APICAL INDUSTRIES, INC.
dba DART AEROSPACE

ENGINEERING CHANGE NOTICE NO.

07034

DWG NO. 645.7700

SHEET 1, FRONT AND RIGHT VIEW WAS:

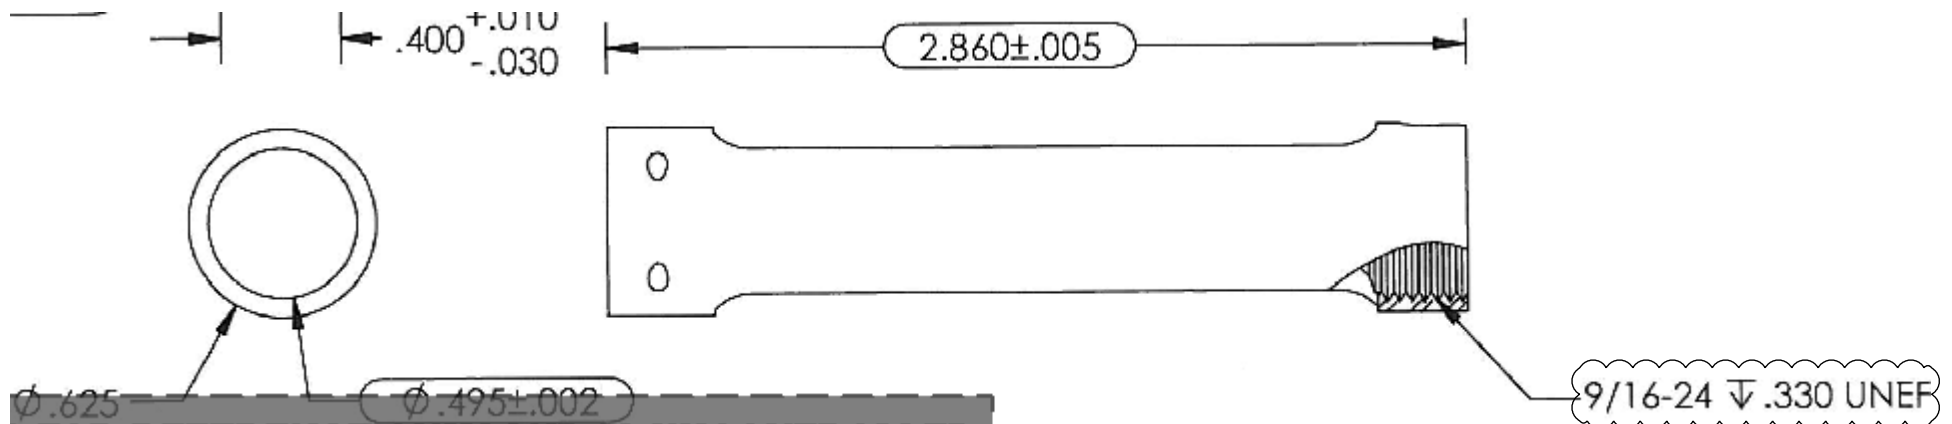
REASON: REVISED TEMPLATE AND VIEWS FOR CLARITY. REVISED NOTES. REVISED THREAD CALLOUT. TIGHTENED .400 SLOT TOLERANCE. ROUNDED UP R.125 TYP DIMENSION TO R.13 4 PL.
